Major Discretionary Review

HIS19-15MOD1 189 Liberty Street NE

Historic Landmarks Commission

HIS19-15

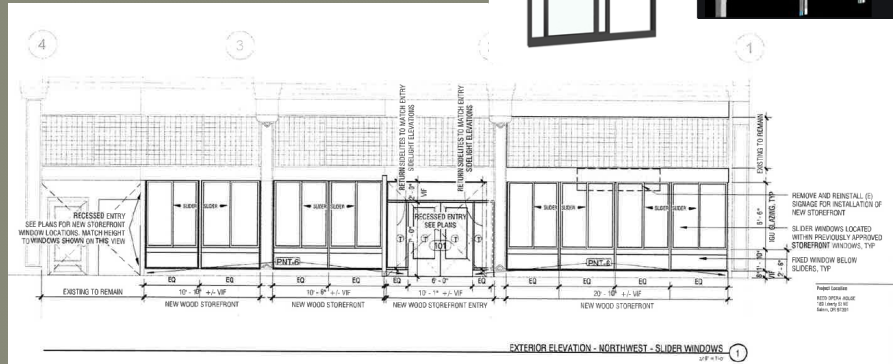
Relocate door and Replace Storefront

Approval to remove awnings and remove and relocate an existing entrance approximately 16' to the east, requiring replacement and extension of the storefront on the western end of the Reed's northern façade.

Install aluminum sliding glass windows

Custom made Milguard Aluminum sliders (10' by 7' high)- 30" above grade over a fixed window- separated by a horizontal mullion. The fixed window will be installed within the wood storefront over the existing stucco bulkhead. The original drawings included in the notice said 'clad' but they are not.
